## NOVI CORPORATE CAMPUS #6 SP 07-74

### **NOVI CORPORATE CAMPUS #6, SITE PLAN NUMBER 07-74**

Public Hearing on the request of General Development Company for Preliminary Site Plan, Woodland Permit and Stormwater Management Plan approval. The subject property is located in Section 9, north of Twelve Mile Road, east of West Park Drive in the OST, Planned Office Service Technology District. The subject property is approximately 3.30 acres and the applicant is proposing to build a 45,095 square foot speculative office/warehouse building with accessory parking facilities on Lot 6 in the Novi Corporate Campus development.

## PLAN REVIEW CENTER REPORT

**SITE  
PLAN**

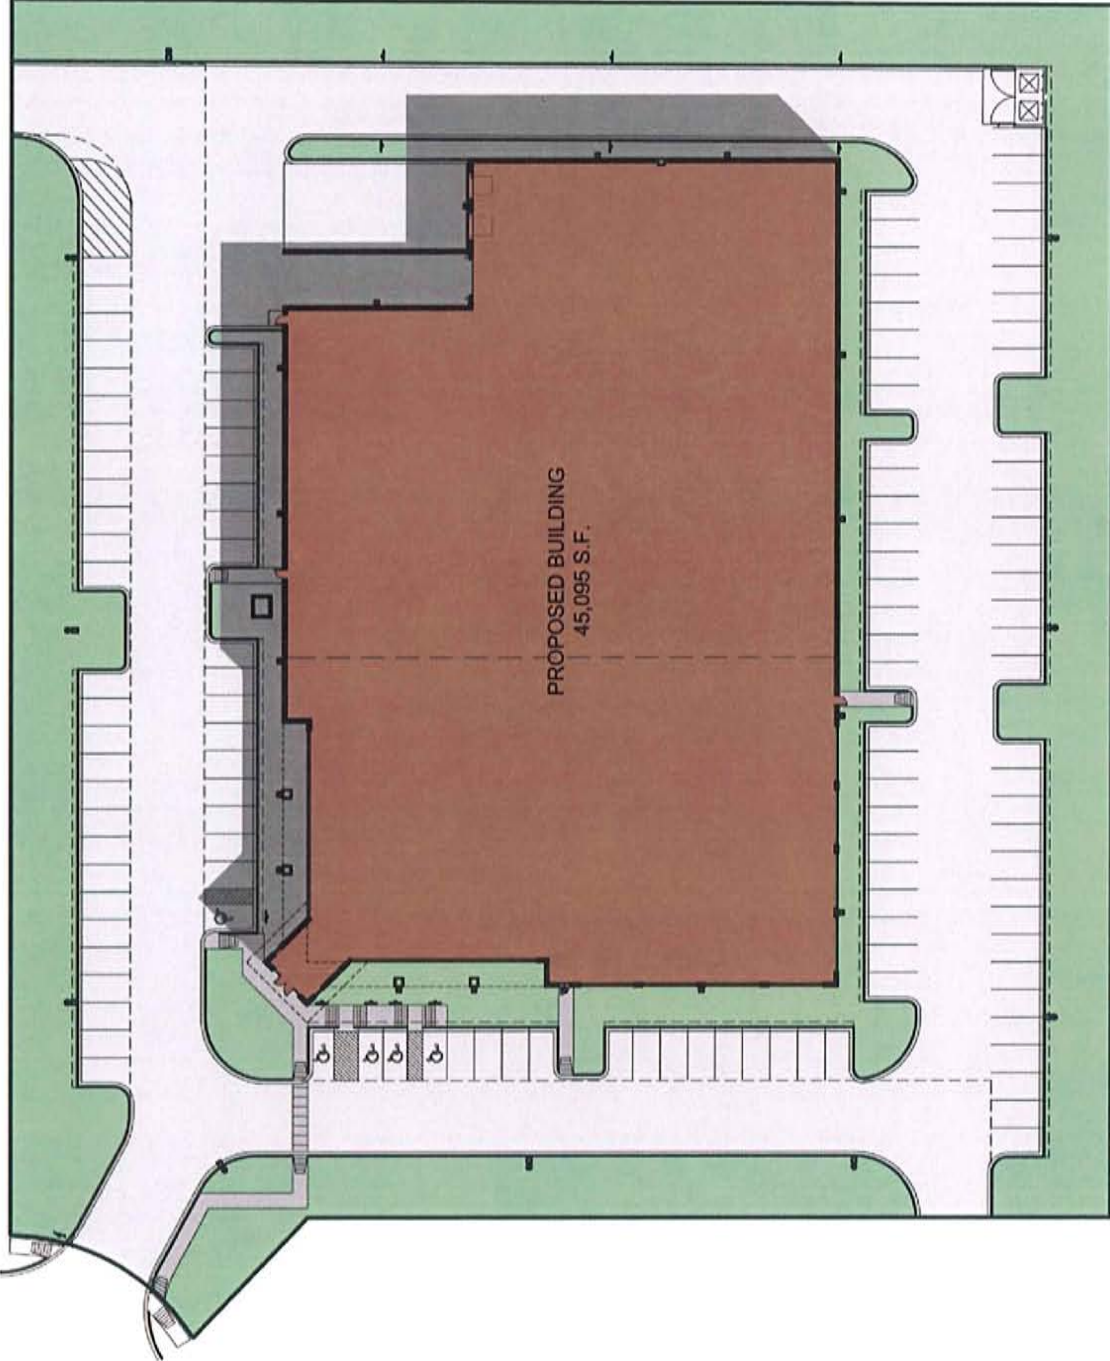
2. The following minor corrections should be made on the Final Site Plan:
  - a. Sheet SP.101- Site Statistics should be revised to indicate the site is zoned OST, not OST and I-2.

1. **Consistency of the Information:** We noted that the information provided on Architectural Site Plan does not match that provided on Engineering Site Plan. This includes, but not limited to, MDOT ADA compliant ramp designation, dimensioning of the handicapped parking stalls, etc. Such anomalies should be sought and corrected.

4. **Parking Stall Dimension:** Typical dimension for the parking stall adjacent to the curbed island, in terms of its width from the face of the curb, should be provided on the site plan.

**Item #2a:** The site statistics have been revised to read 'OST'.

**Item #1:** The architectural site plan has been updated to be consistent with the engineering site plan.

**Item #4:** Typical parking stall dimensions have been noted on sheet SP.101
